LAND PLANNING, INC.

Attention: Michelle Buck, Town Planner
Subject: Submission of revised plans for Cultivate dated July 3, 2019
Reference: Topnotch Realty Corp, 1762 Main Street, Leicester, proposed new parking lot

PIPE SIZE: 24" HDPE

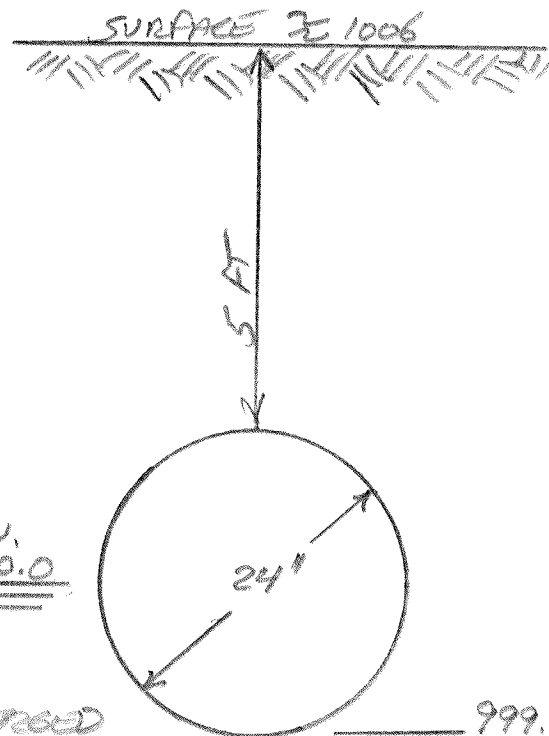
- 11 Please find attached a copy of our buoyancy calculations, which show that the HDPE pipes will not float.

BUOYANT FORCE OF PIPE:

ASSUME PIPE IS FULLY SUBMERGED

$$A = \frac{\pi D^2}{4} = \frac{\pi 2^2}{4} = 3.14 \text{ FT}^2$$

$$\text{LIFT} = (3.14 \text{ FT}^2)(62.4 \text{ #/FT}^3) = 196 \text{ #/FT OF PIPE}$$

WEIGHT OF SOIL COVER:

$$\text{SOIL VOLUME} = (5 \text{ FT})(2 \text{ FT}) = 10 \text{ FT}^3 \text{ / FT OF PIPE}$$

$$\text{SOIL WEIGHT} = (10 \text{ FT}^3)(110 \text{ #/FT}^3) = 1100 \text{ #/FT OF PIPE}$$

$1100 \text{ #} > 196 \text{ #} \therefore$ PIPE WILL NOT BE
DISPLACED BY GROUNDWATER
